Noise Symptom - Clicking Noise From Brake When Changing Direction: Replacing retainer spring for brake pad (SY 88/18)

Model Line: **Cayenne (9YA)**

Subject: **Retainer spring for front brake pad**

Brake caliper

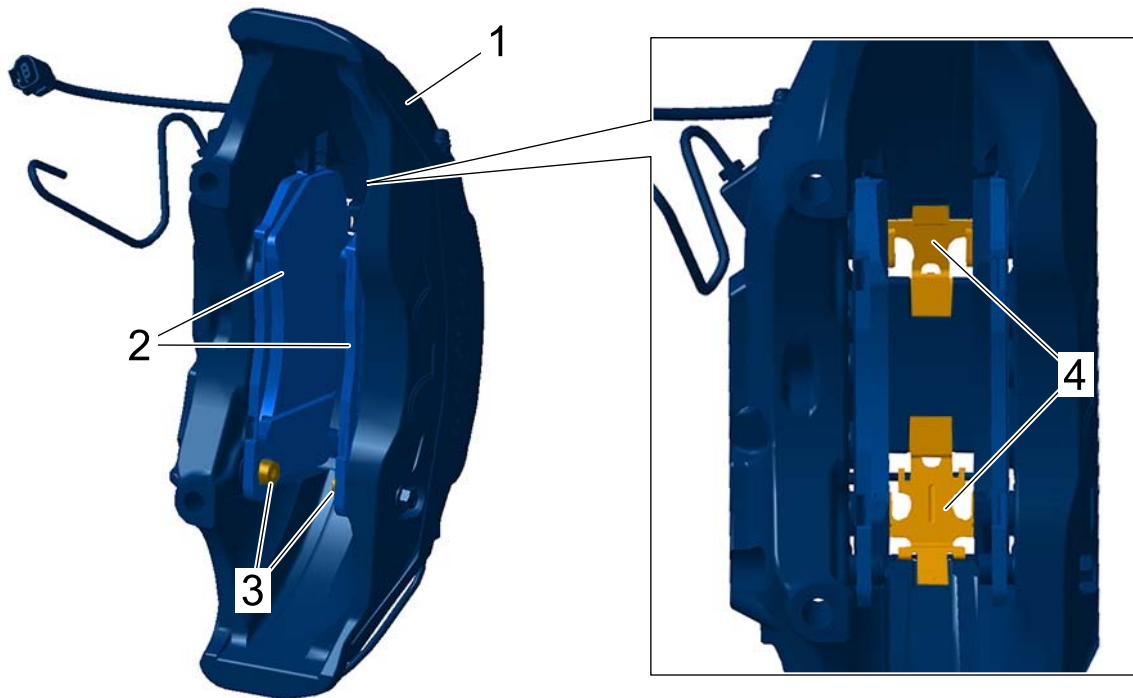
Symptom: A clicking noise can come from around the front axle when changing direction of travel or when braking suddenly while driving slowly.

Cause: During load changes or changes in direction, the brake pads can hit against the brake caliper and cause the clicking noise.

Remedial Action: In the event of a customer complaint, replace the existing retainer springs for the brake pads with new **rubber-coated** retainer springs (⇒ *Brake caliper -4-*), see:
